Access Compliance Report

Public Rights-of-Way

(Curb Ramps)

Intersection ID: 49926	Main Street: CAMPBELL_HALL_CT	Cross Street: WOBURN_RD	Location: SW
ADA ID: D10D60C05525	Ramp Type: Perp	Initial Pass/Fail: Fail	Overall Compliance: No
Severity Score: 22.5			
Codes/Mitigation Info/Possible Solution		Field Measurements/Component Compliance

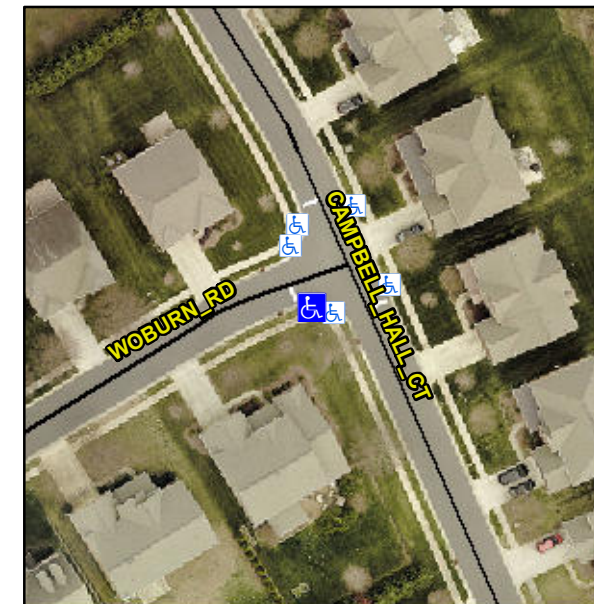
Not Found, R304.5.1, R304.2.2, R304.5.3

Compliance	Description	Data	Compliance	Description	Data
N/A	Ramp Length (in)	48.0	No	Ramp Slope (%)	9.0
No	Ramp Width (in)	46.0	No	Ramp XSlope (%)	3.1
N/A	Flare Type LT	N/A	N/A	Flare Type RT	N/A
N/A	Flare Slope LT (%)	N/A	N/A	Flare Slope RT (%)	N/A
N/A	Flare Traversable LT?	N/A	N/A	Flare Traversable RT?	N/A
N/A	Landing Length (in)	N/A	N/A	DWS Provided?	N/A
N/A	Landing Width (in)	N/A	N/A	DWS Contrast?	N/A
N/A	Landing Slope (%)	N/A	N/A	DWS Length (in)	N/A
N/A	Landing X Slope (%)	N/A	N/A	DWS Full Width?	N/A
N/A	Landing Curb? (Y/N)	N/A	N/A	DWS Offset (in)	N/A
N/A	Shared Landing?	N/A			
N/A	Gutter Ponding?	N/A	N/A	Gutter Slope (%)	N/A
N/A	Gutter Lip Ht (in)	N/A	N/A	Gutter X Slope (%)	N/A
N/A	Painted X Walk1?	No	N/A	Painted X Walk2?	N/A
	X Walk 1 Direction	To NW		X Walk 2 Direction	N/A
N/A	X Walk 1 Width (in)	N/A	N/A	X Walk 2 Width (in)	N/A
	X Walk 1 Slope (%)	4.1		X Walk 2 Slope (%)	N/A
	X Walk 1 X Slope (%)	2.4		X Walk 2 X Slope (%)	N/A

Remove & Replace Entire Ramp.
